Moss Vale Road North Urban Release Area Traffic Study

Internal Traffic Analysis Report

Shoalhaven City Council

29 July 2020

Figure 5.2: Proponent's Road Typology with Council's Original Amendments (Prior to the May 2020 TRACKS Update)

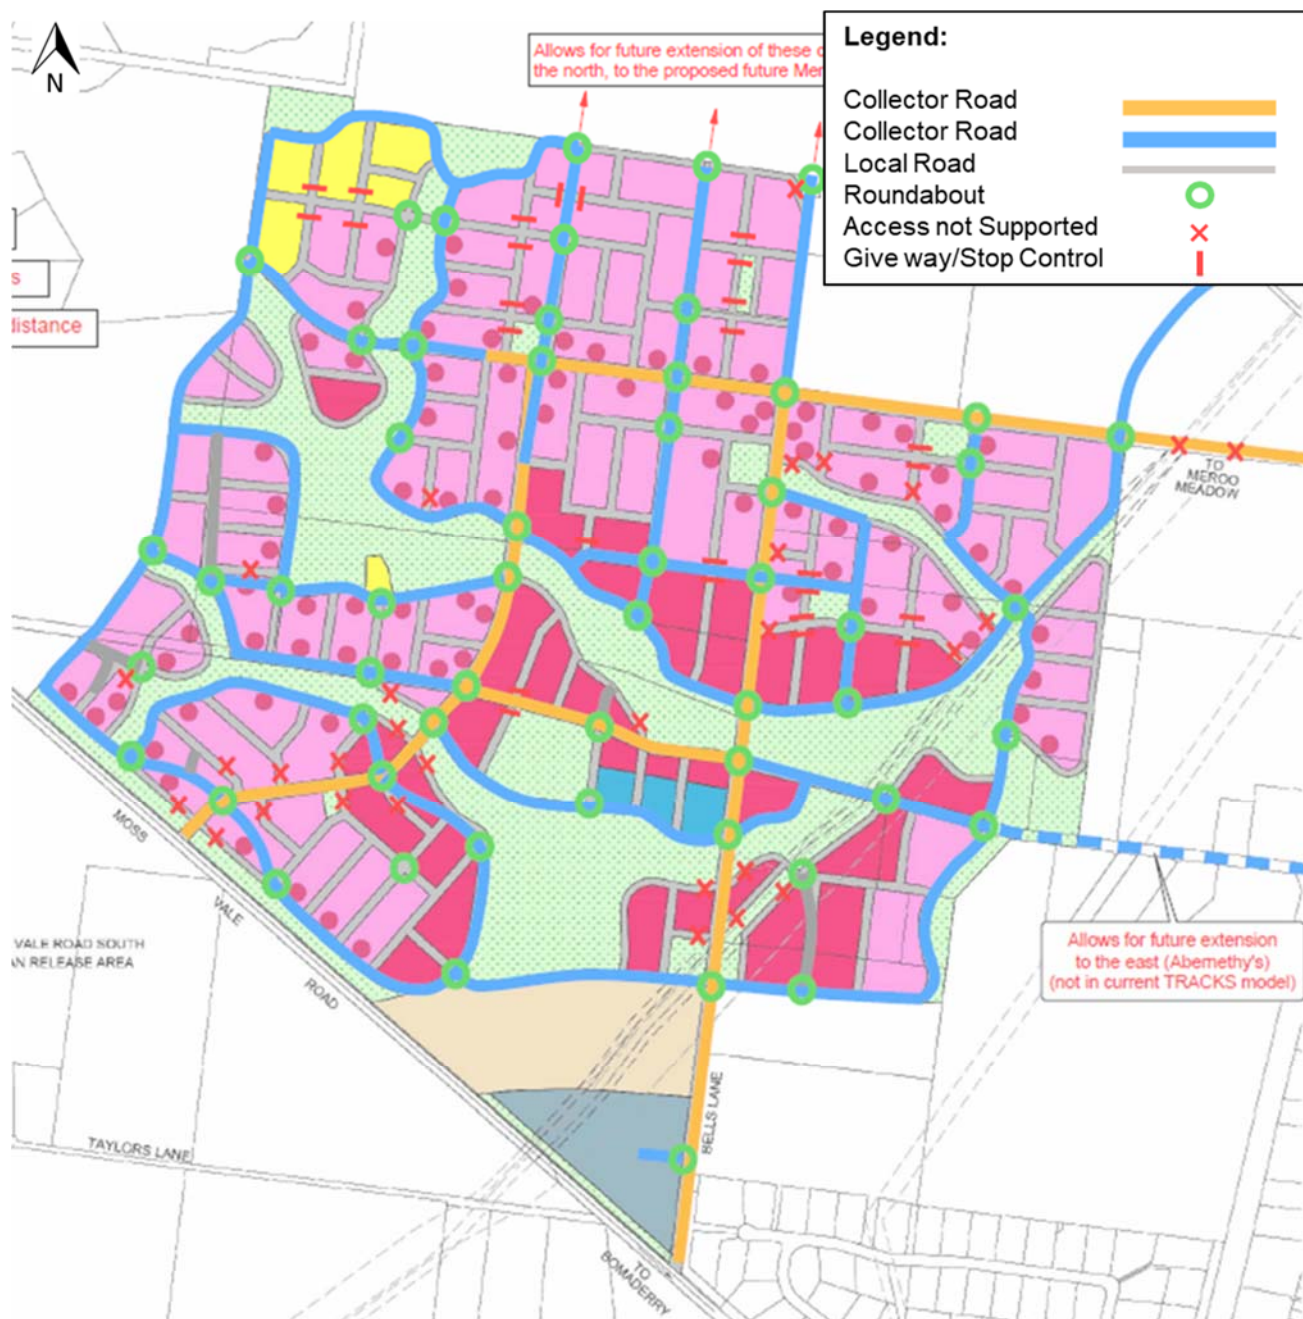
Council provided an amended sketch based on the proponent's proposed road network layout plan, as detailed in Figure 5.2. Council proposed extensions to the collector road network and provided advice related to indicative roundabout and access locations throughout the development.

Figure 5.3: Proposed Road Network Layout and Typology

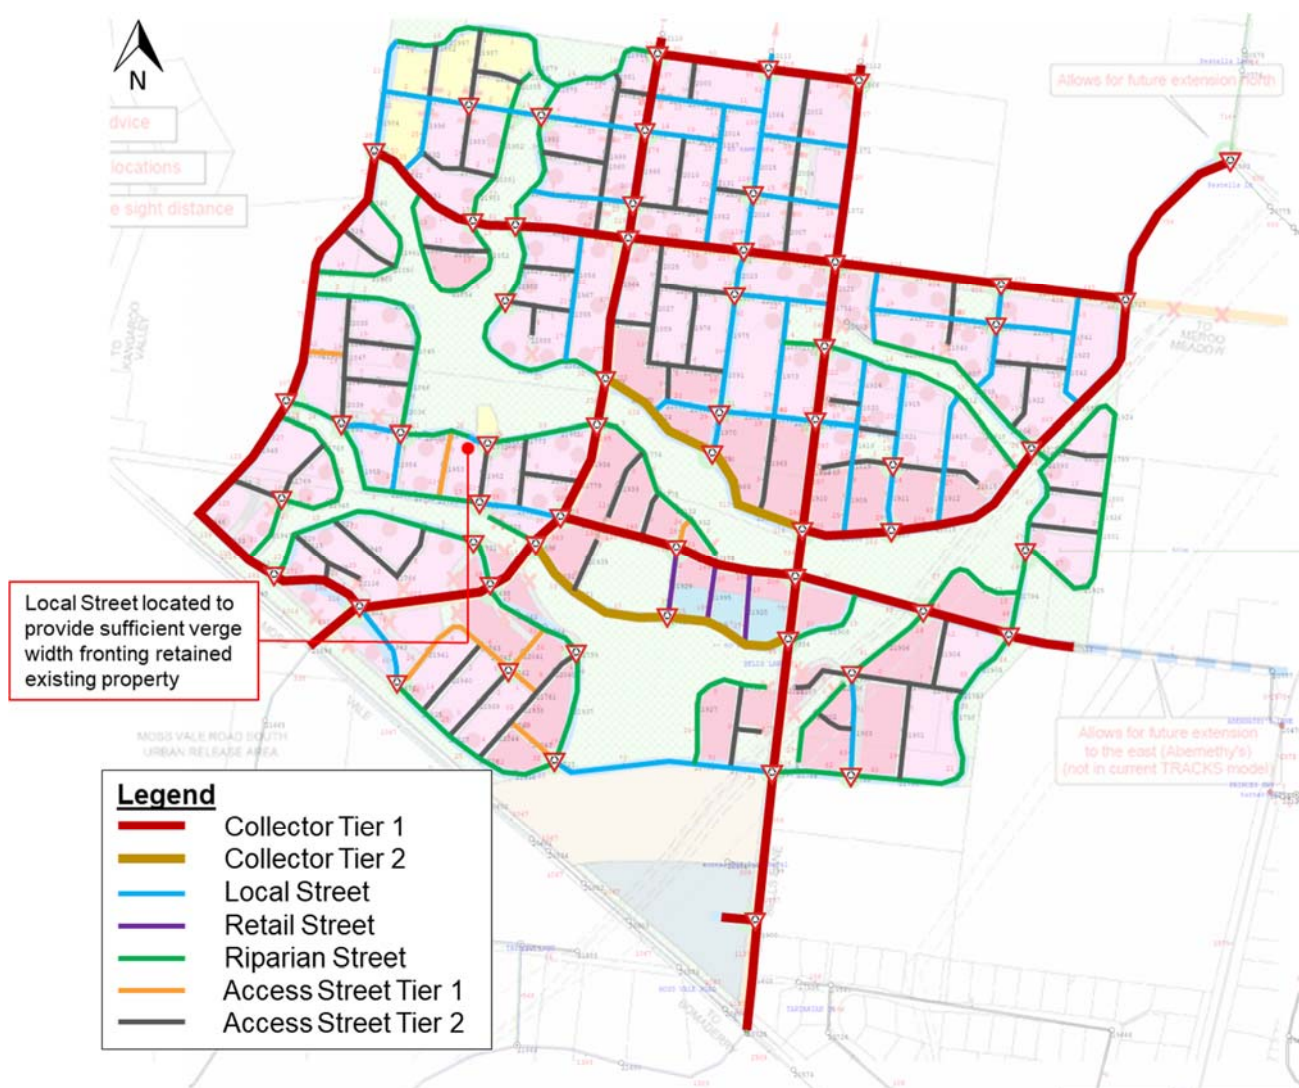
It is recommended the road typology provided in the MVRN Draft DCP is amended to reflect that shown in Figure 5.3.

Figure 5.7: Proponent's Proposed Central Boulevard Alignment

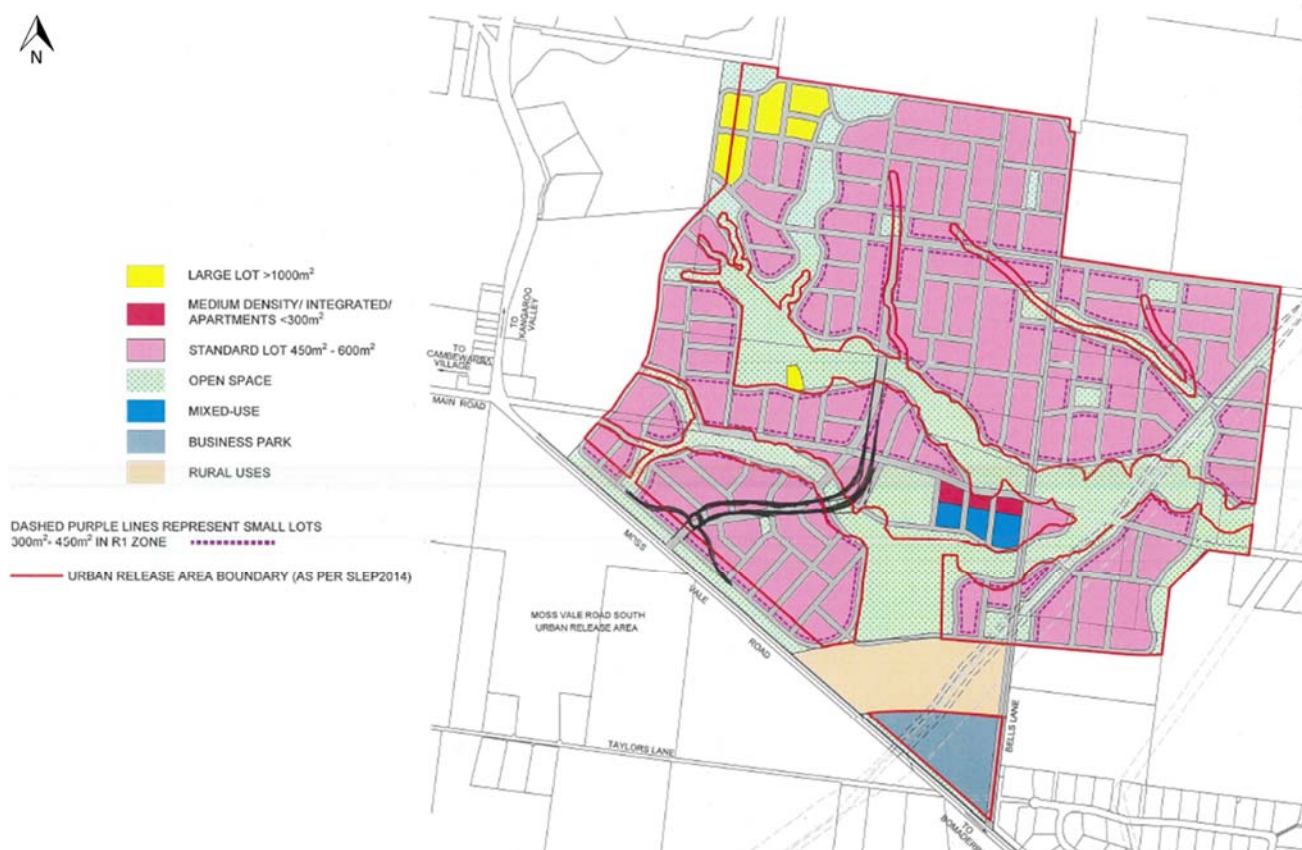
The radius of the new proposed curves of Central Boulevard appears to be less than those previously proposed by the proponent. In the absence of detailed plans, the new proposed curves result in a less desirable outcome, particularly where side streets are located on the inside of the new proposed curves. The position of side streets on low radius curves is likely to result in insufficient safe intersection sight distance (SISD).

This revised layout has only been proposed during the final stages of this internal traffic report. Notwithstanding, subject to a more detailed engineering review of the revised road geometry, the current proposed road layout and associated roundabout locations could be augmented to suit the revised Central Boulevard road alignment, without any change to the number of intersections or roundabout locations. However, on the basis of the marginally poorer alignment, one possible mitigation measure may be to extend the 'access restrictions' from the first roundabout to the Village Boulevard, to protect the integrity of the network in response to the suggested change.

Figure 6.4: Open Space Masterplan

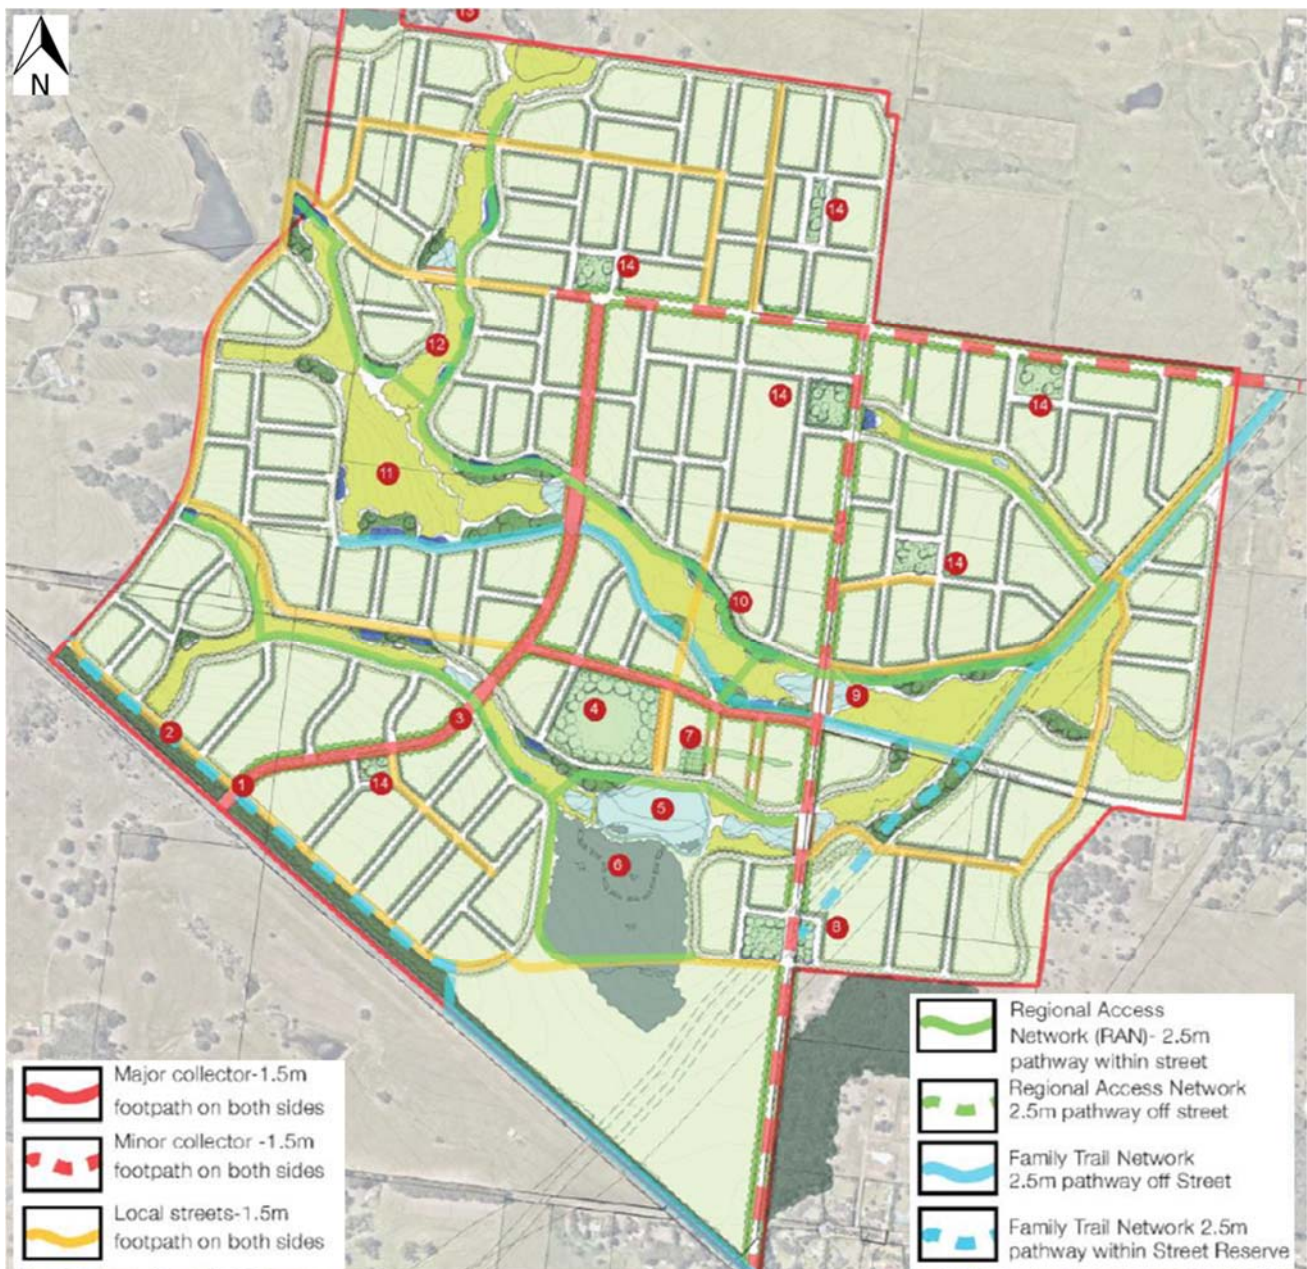
Recommendations for the above open space masterplan are detailed as follows:

- 2.5m shared use path is not recommended through the north-south retail streets to the south of Village Boulevard given:
 - These streets are recommended as retail streets and a shared use path cannot be provided without narrowing the recommended planting width and increasing offset width within the verge
